Public Hearing

CASE SUMMARY SHEET

CASE NUMBER: V26-06-17
DATE RECEIVED: April 30, 2026
DATE OF MEETING: June 9, 2026 and June 23, 2026

REQUEST: V26-06-17 – Robert and Karen Bordes request a variance to CLURO Section 8.1.5. Supplemental Regulation of Accessory Buildings and Structures and Section 5.2.3.3. Fill Sub-Area B, Old Town of Mandeville, Square 43B Lot C, O/R - Office/Residential District, 724 Carroll

BARN PLANS FOR: BORDES
724 CARROLL STREET
CITY OF MANDEVILLE, LA

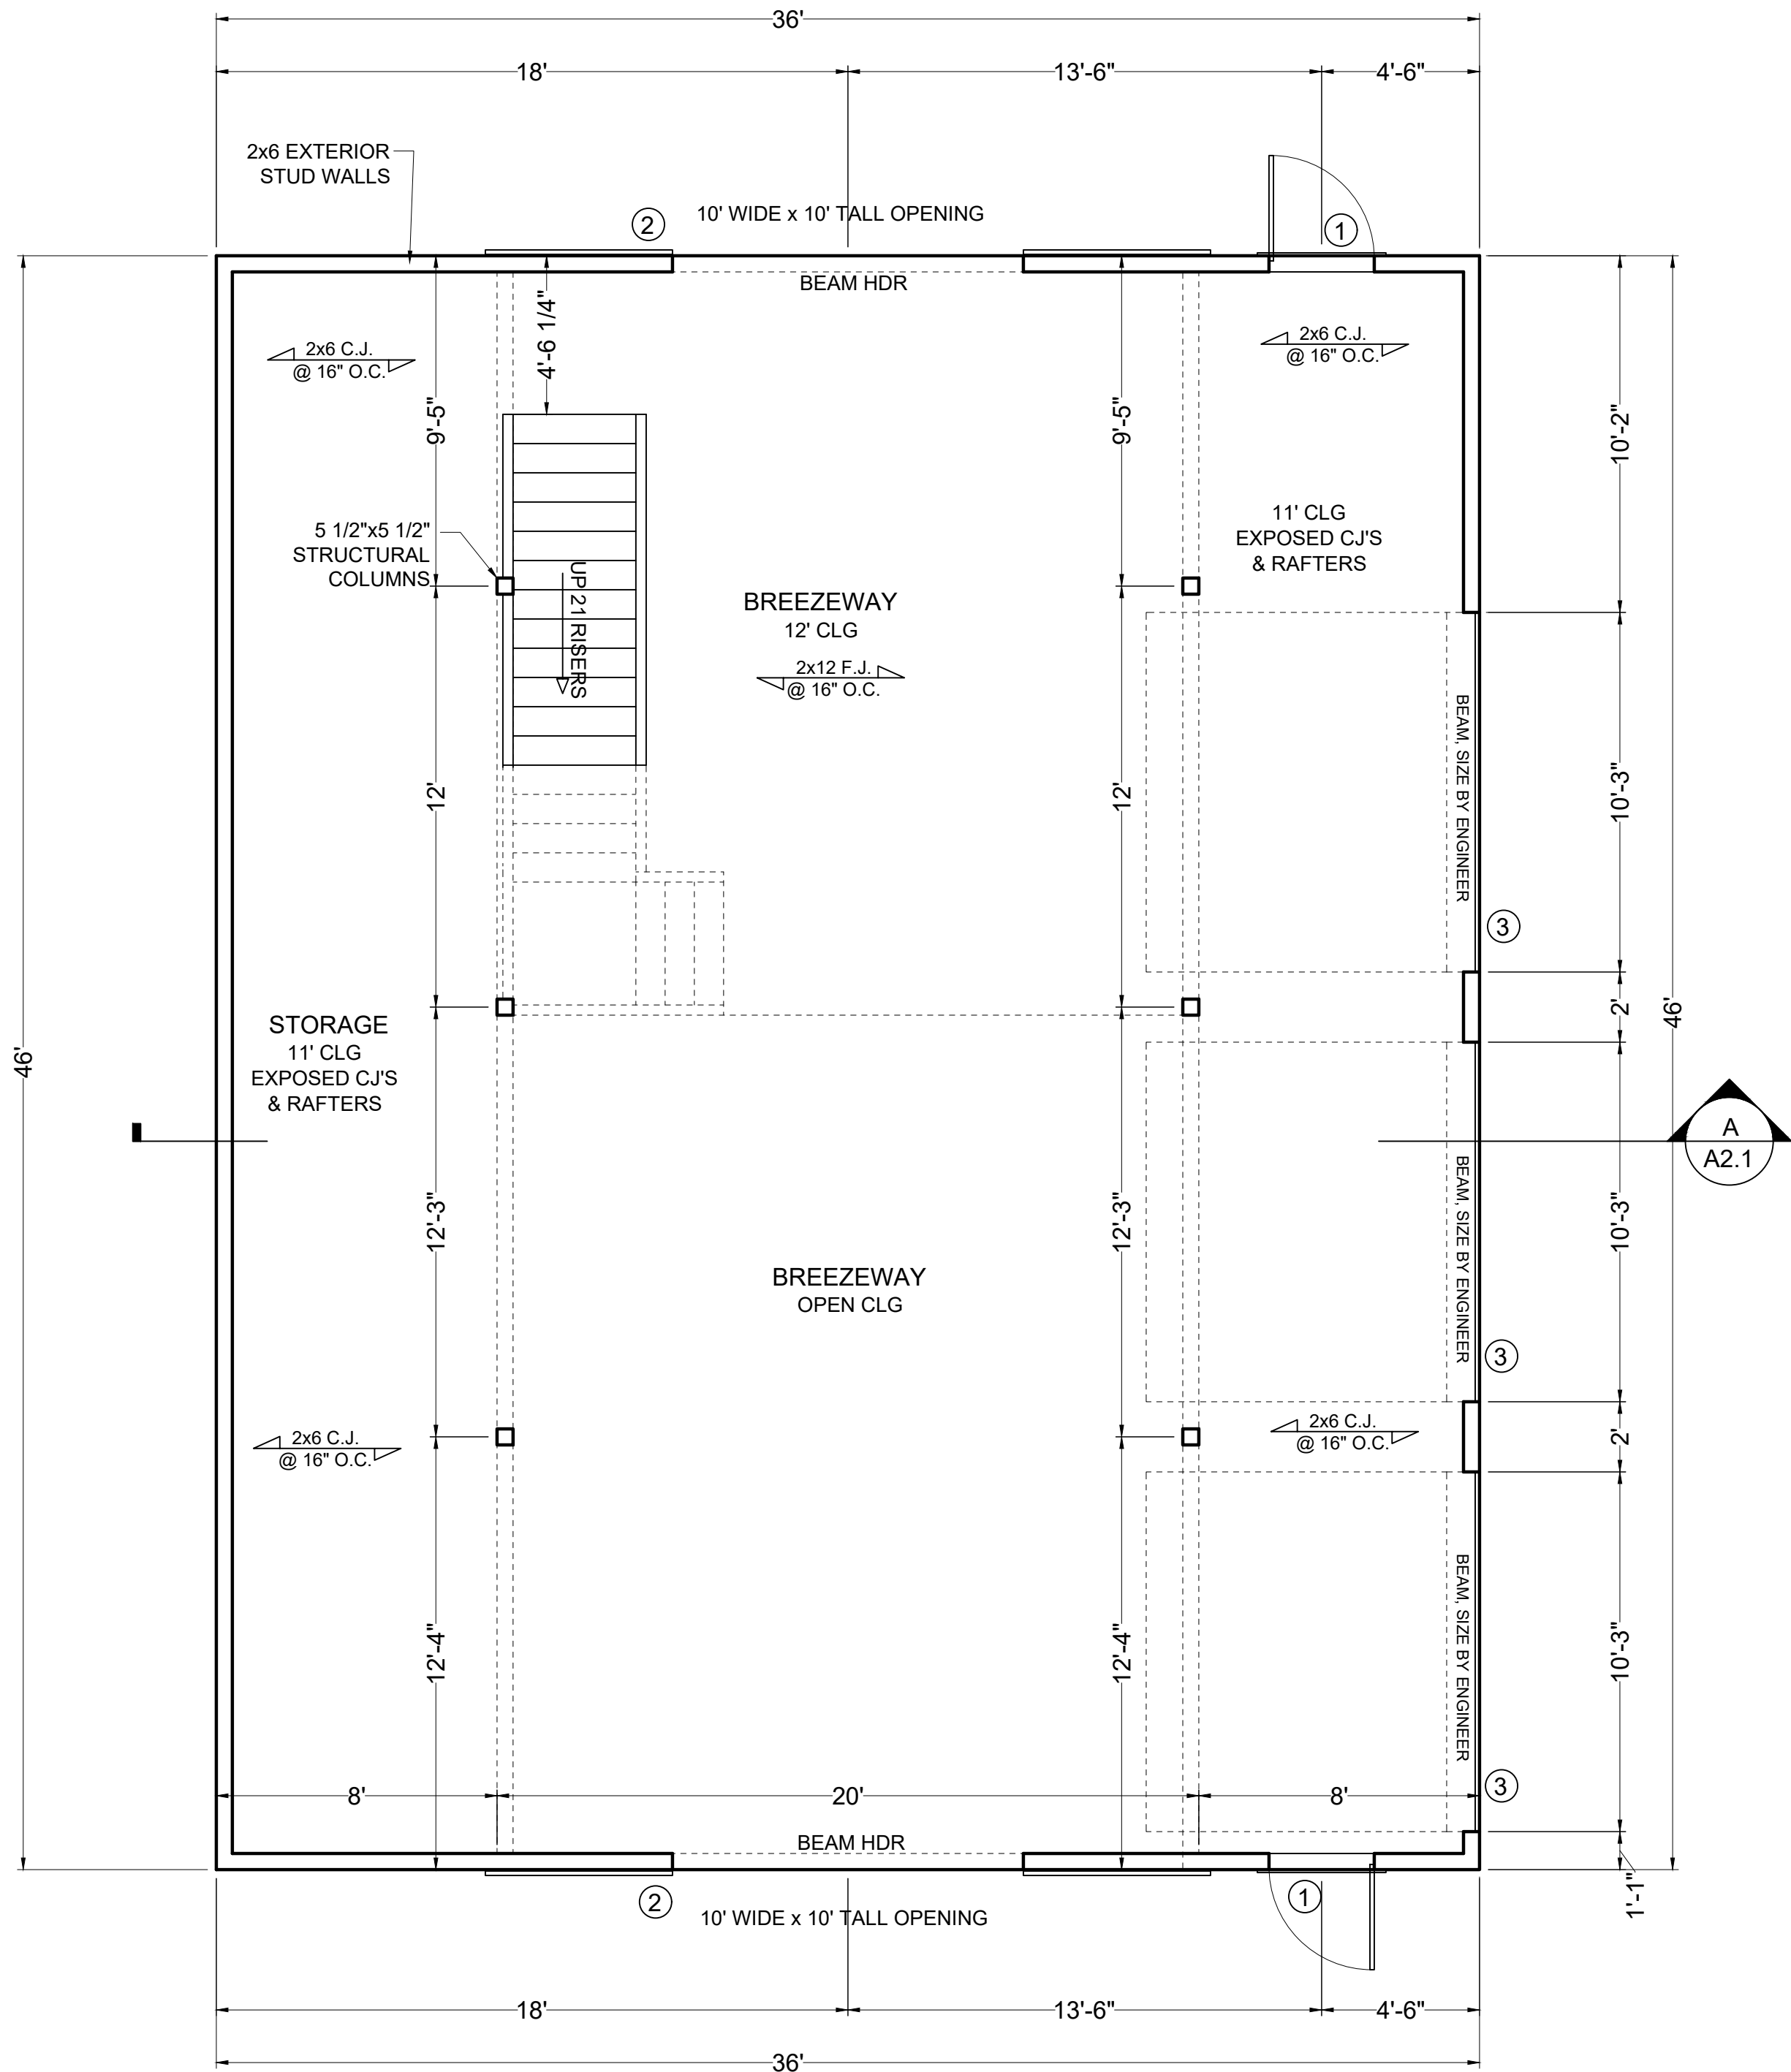
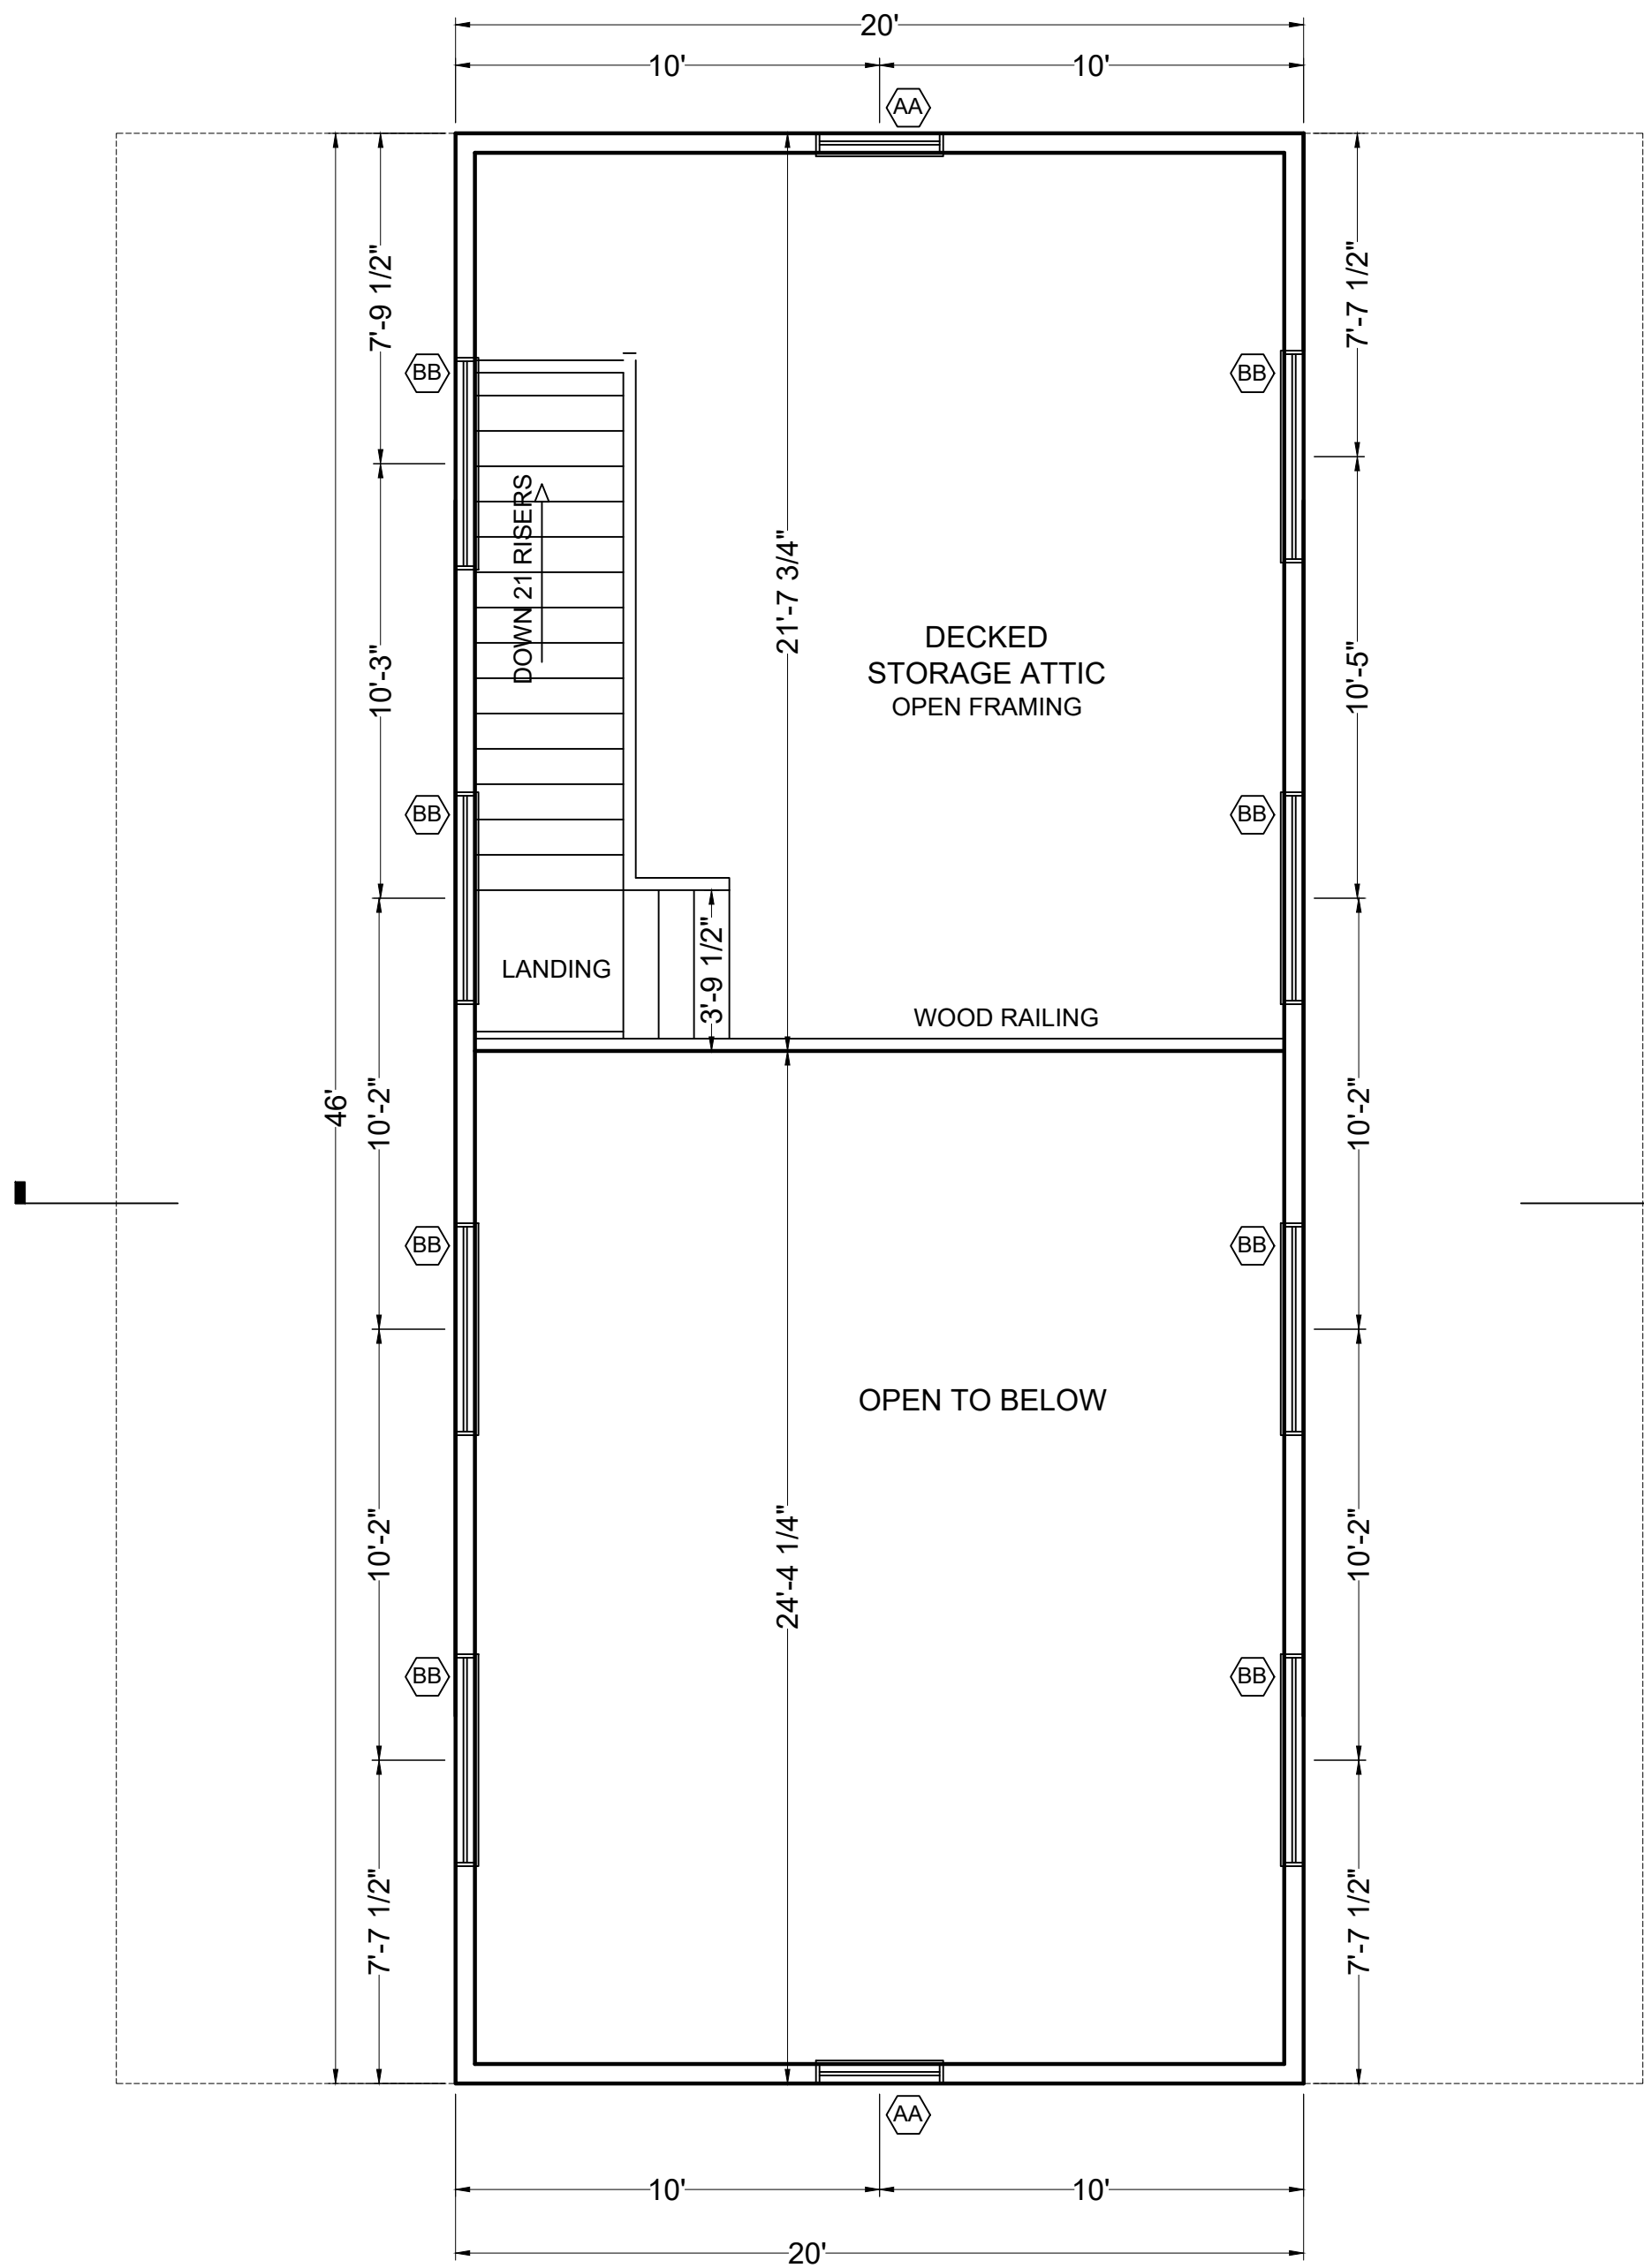
Regulations limit the height of accessory structures to no more than 14’, and the combined gross area of all accessory structures located in the side or rear yard to not exceed 30% of the rear yard area. The rear yard is 1,137 sqft, requiring the accessory structure to be no more than 341 sqft in size. The barn is located in the rear of the property and is proposed to be 1,656 sqft and 26’-5 ½” tall.

To be allowed by right at the current proposed height and size the accessory structure would have to be located fully within the buildable area. This would be 15’ from the rear and 18’ from both side property lines. Currently the accessory structure is located 12’ from the north side property line. It is compliant with the rear and south side distance.

The accessory structure is located within an AE 9 flood zone. Flood regulations require that accessory structures located within a flood zone cannot exceed 600 sqft. The structure would need to be elevated to BFE + 2’ or 11’ to be larger than 600 sqft. If the structure was fully located within an X zone there would be no size restriction. Public Works reviewed the request and had the following comments:

“We do not have a drainage plan produced for this building, but I can use information provided from the documents submitted for the permit on the primary structure. The applicant is proposing elevating the slab for the garage to Elevation 11.0 to comply with FEMA regulations. However, Section 5.2.3.3 Fill Sub-Area B 3 Slabs for Non-Habitable Areas only allow “6” inches (0.5’) of height above grade for any other slab”. The average existing elevations within the area of the proposed garage is (8.65’) . Fill Sub Area B would only allow the top of slab to be elevated to (9.15’). The variance request is to elevate the slab to elevation (11.0) a difference of (1.85’) . Additionally, 5.2.3.3 Fill Sub-Area B 1.f. allows for elevating the driveway 6” except within 16’ of the slab to ramp up onto the bottom slab. An additional variance maybe required for the driveway depending on the desired slope to access to building. According to the drainage plan submitted for the primary structure a 1% slope is shown for the driveway approaching the building. If the owner is looking to achieve the same slope the driveway surfacing near the garage would need to be elevated to (10.7’) which would result in fill height for the drive (1.1’) above the allowable (0.5’)”.
